Addendum No. 4

Date: February 28, 2012

PROJECT: Long Branch – George L. Catrambone Elementary School

CONTRACT No.: ET-0068-C01

REFERENCED DRAWING
 DETAIL/SHEET # 1/ A-1.1
 DATE: 10-20-11

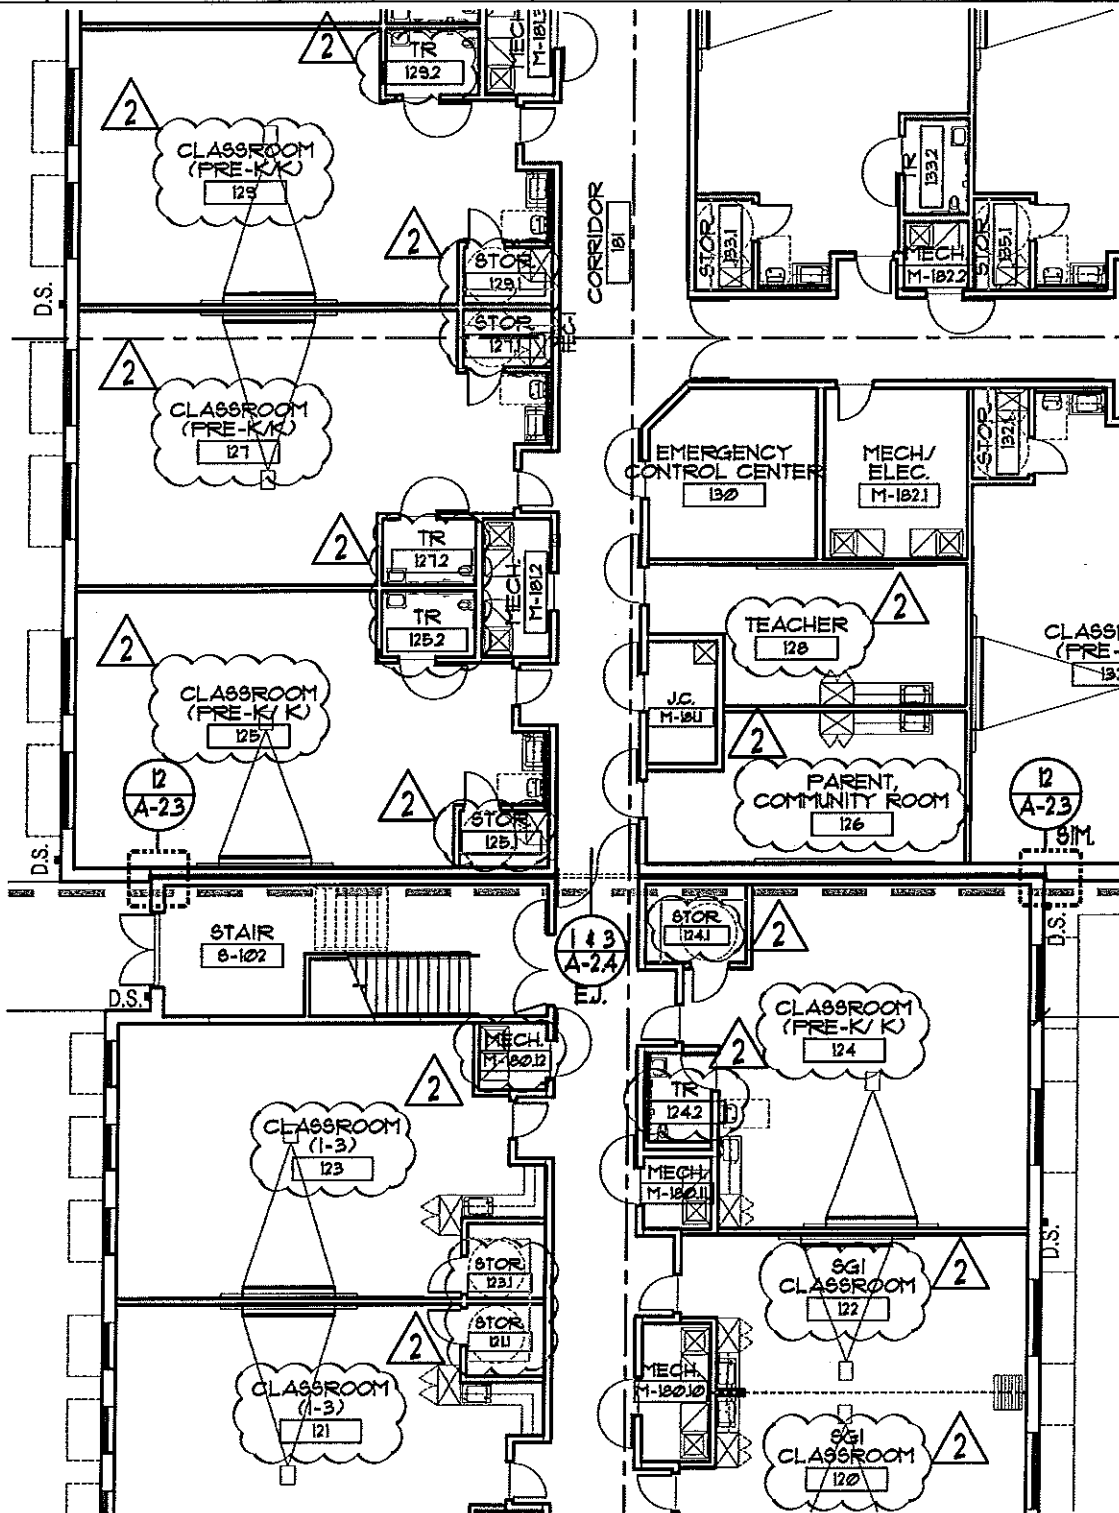
- Detail 1/A-1.1:
 - Revise room number per SK-1
 - Revise detail to provide pocket in CMU wall at door # 178 per Drawing A-1.4 and associated SK-3

1 FIRST FLOOR PLAN- BLOCK "A"
 A-1.3 SCALE: 1/8"=1'-0"

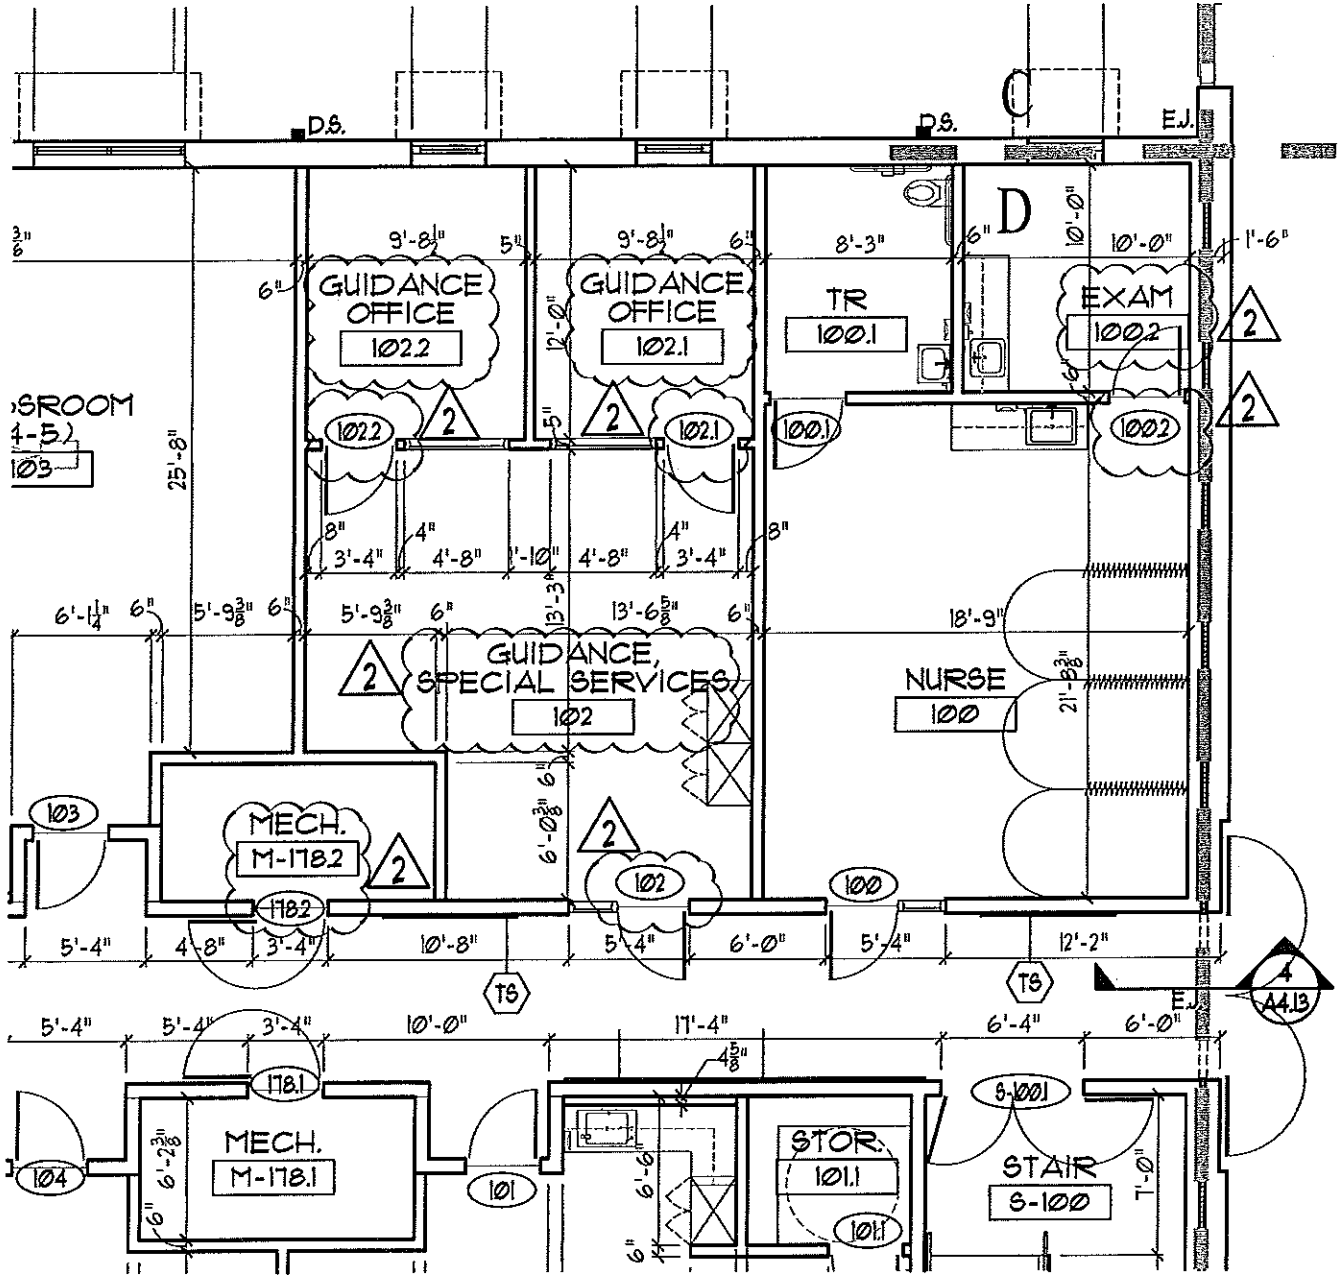
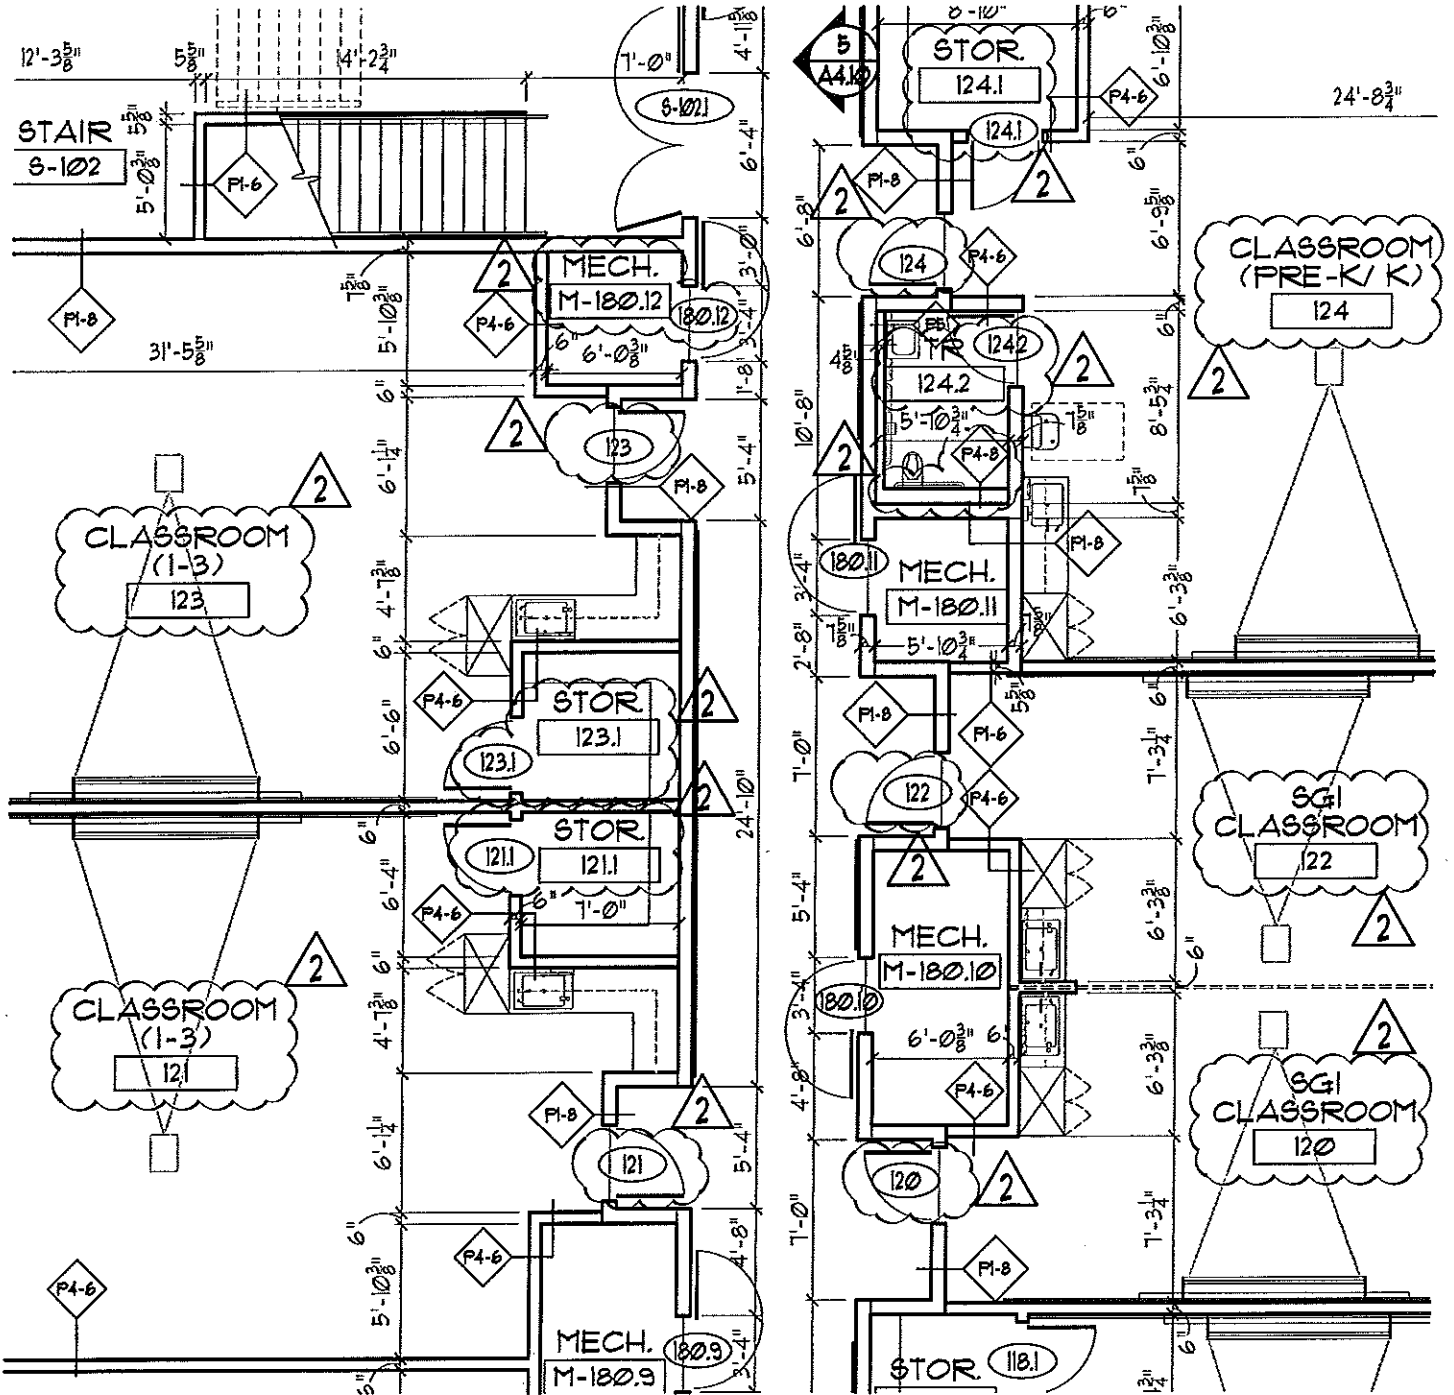
- Detail 1/A-1.3:
 - Revise room numbering and door numbering per SK-2.
 - Revise room numbering and door numbering per SK-3.
 - Revise room and door numbering for “TR” serving SE Classroom 106 to be TR 106.2 and associated door 106.2.
 - Revise room and door numbering for “TR” serving SE Classroom 108 to be TR 108.2 and associated door 108.2.
 - Revise room numbering for “Girl’s Toilet” from 180.1 to 180.2 and associated door numbering from 180.1 to 180.2.

1 ROOF PLAN
A-2.1 SCALE: 1/16" = 1'-0"

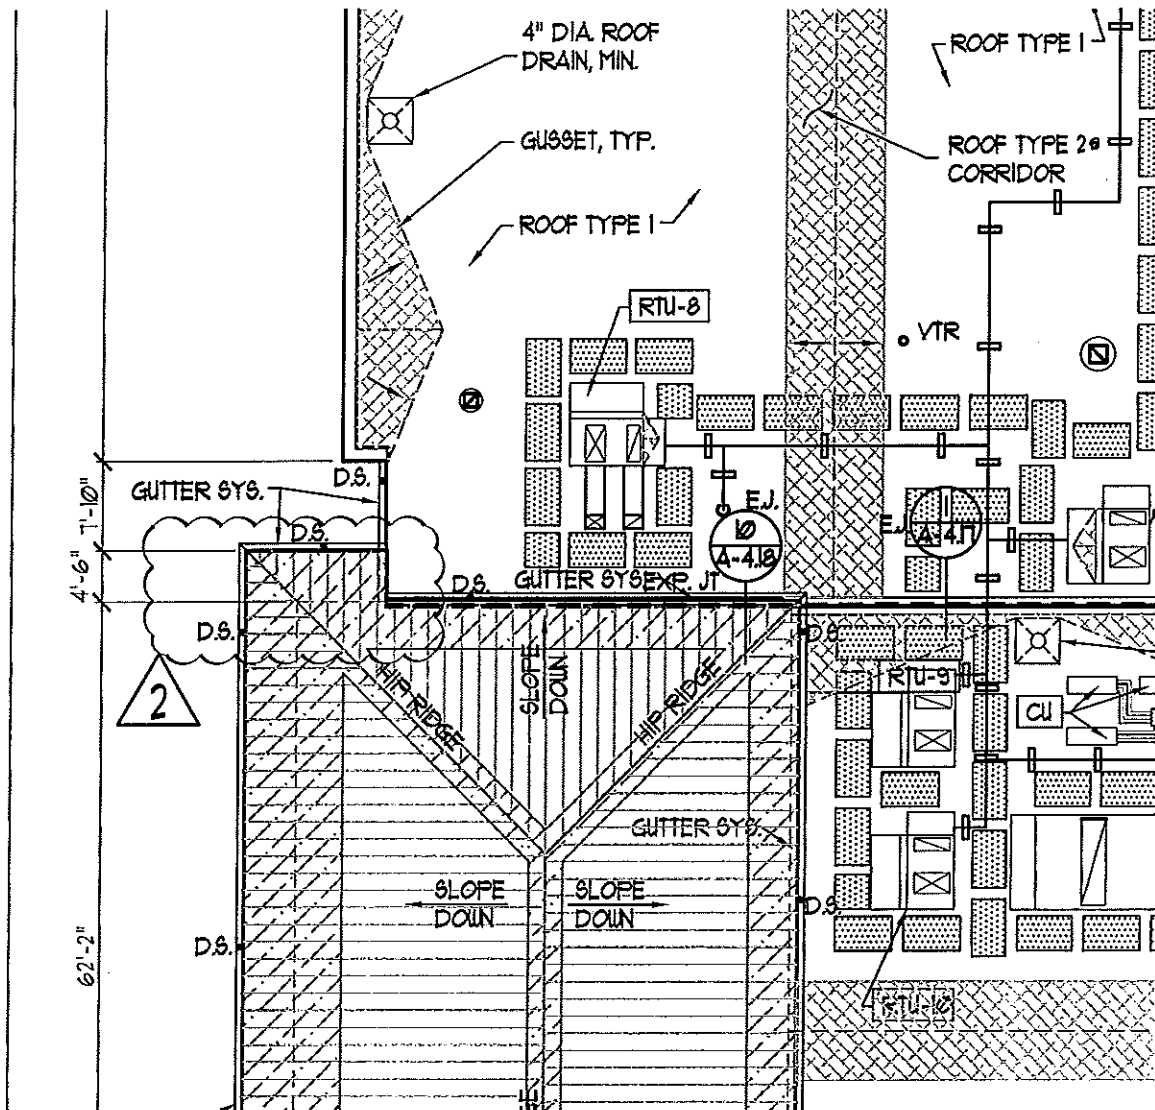
- Detail 1/A-2.1:
 - Revise extent of sloped roof overhang at Media Center per SK-4. Roof overhang shall terminate flush with exterior face of CMU veneer at two-story wall below.
 - Add following note at roof drains located in Block "B"- 'MINIMUM STARTING THICKNESS OF RIGID INSULATION SHALL BE 2" AT ROOF DRAINS (BLOCK 'D') AND SHALL TAPER IN ACCORDANCE WITH DETAILS ON DRAWING A-2.2'
- Detail 4/A-2.1:
 - Add the following note 'PROVIDE 6" THICK CONCRETE WITH 4" DRAINAGE COURSE. EXTEND CONCRETE 6" BEYOND CAST IRON PIPING ALL SIDES AND PROVIDE #3 PERIMETER REBAR AT CENTERLINE OF 6" DIMENSION & MIDPOINT OF SLAB'

1 EAST ELEVATION (SIDE)
A-3.1 SCALE: 1/8"=1'-0"

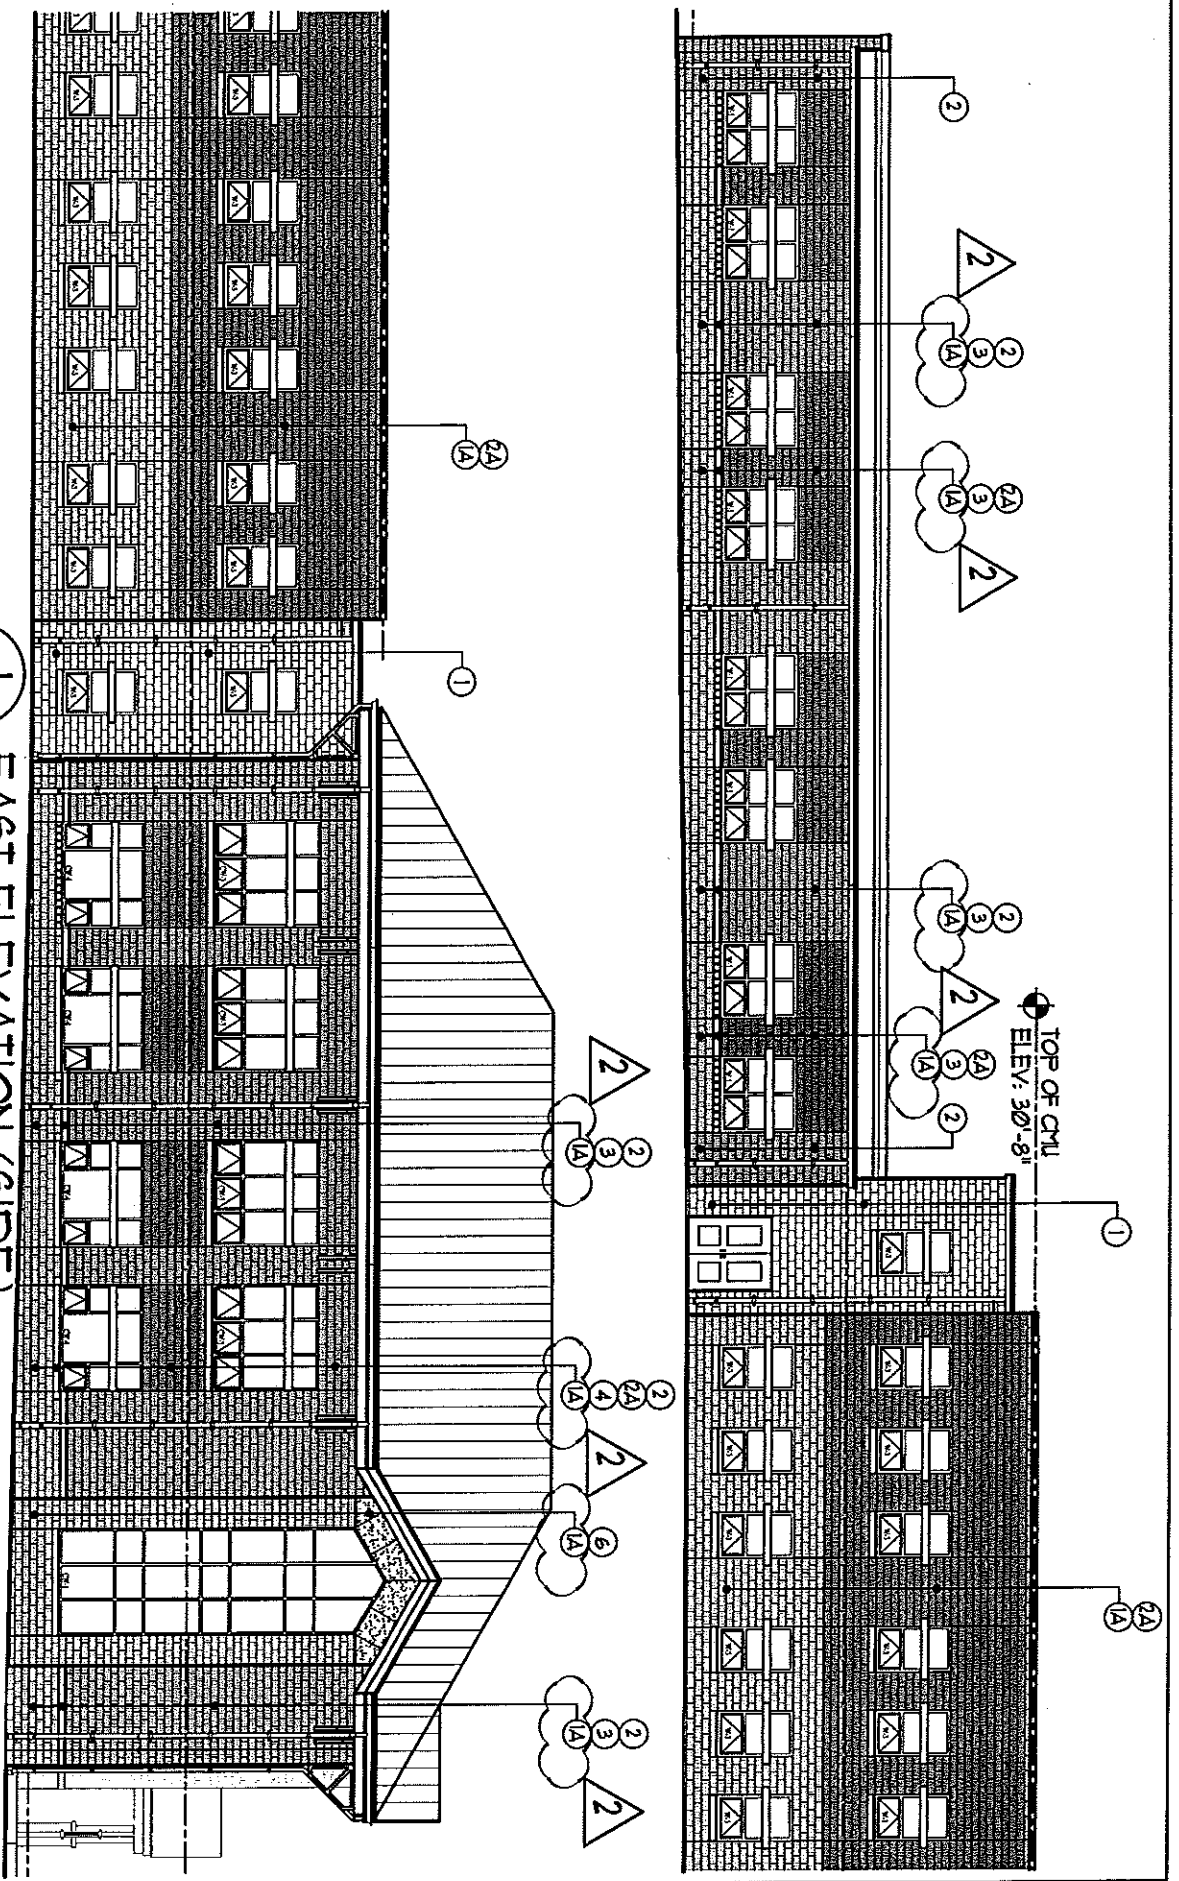
- Detail 1/A-3.1:
 - Revise exterior material #1 to be #1A per SK-5.
- Detail 2/ A-3.1:
 - Revise exterior material #1 to be #1A per SK-6.
- Detail 3/A-3.1:

3 WEST ELEVATION (SIDE)
A-3.1 SCALE: 1/8"=1'-0"

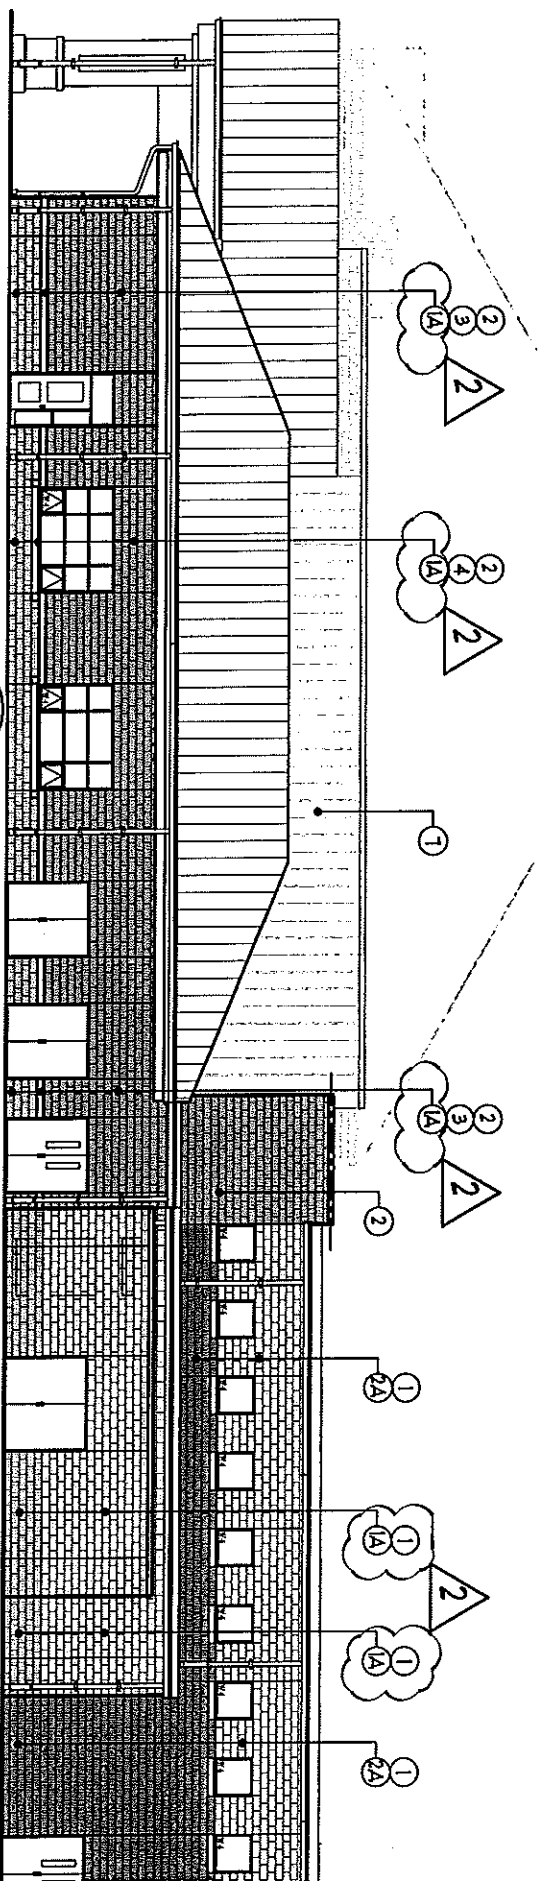
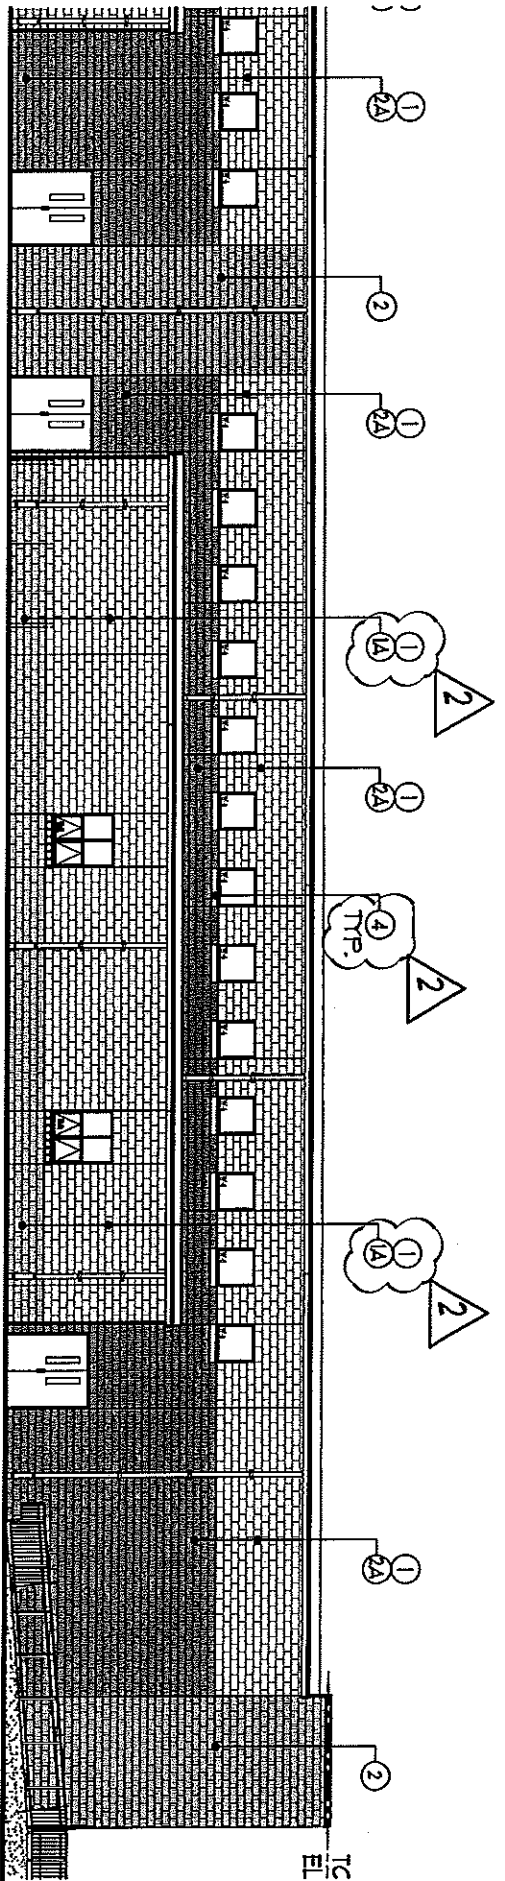
- Revise exterior material #1 to be #1A per SK-7.
 - Provide Cast Stone Window Sill at all Clerestory Windows per SK-7.
- Detail 4/A-3.1:
 - Revise exterior material #1 to be #1A per SK-8.
